From: planning@grangeassociation.com
Sent: 13 September 2021 10:03
To: 'Tom.Hutchinson@edinburgh.gov.uk'
Cc: 'info@roxburghmcewan.co.uk'
Subject: 25 Lauder Road EH9 2JG - NMV 19/03835/VARY
Attachments: 02-EXISTING__PROPOSED_FRONT_GARDEN_PLANS__PROPOSED_ELEVATIONS-5113931.pdf

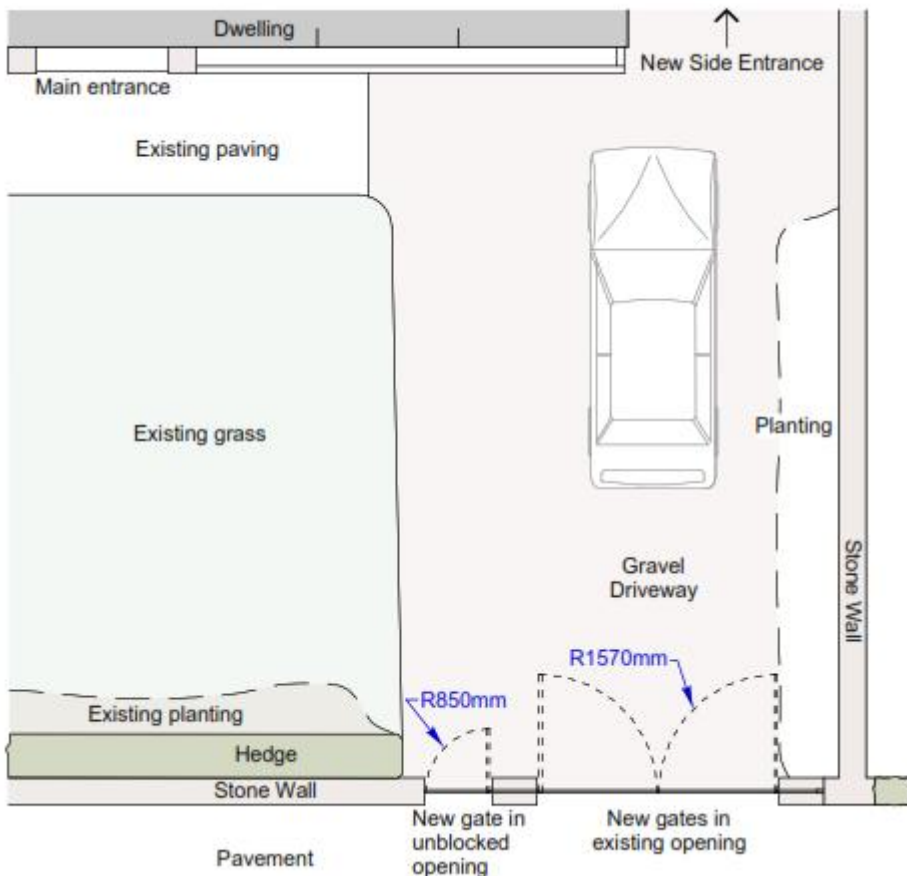
I see that you are the Case Officer assessing [19/03835/VARY](#). We have no objections in principle to what is being proposed here, but we note the inconsistency in the attached drawing. This includes the elevation drawing with the dimensioned 3m width of the driveway entrance, consistent with page 19 of the [Householder Guidance](#). However, the plan view on the same drawing shows two gates, each rotating around their pivot points with a radius of 1570mm, implying a total width of at least 3.14m. Can you ask the applicant please to amend the drawing to ensure consistency and that the entrance is no wider than 3m, consistent with the Householder Guidance? We are keen that as much of the stone wall is retained as possible.
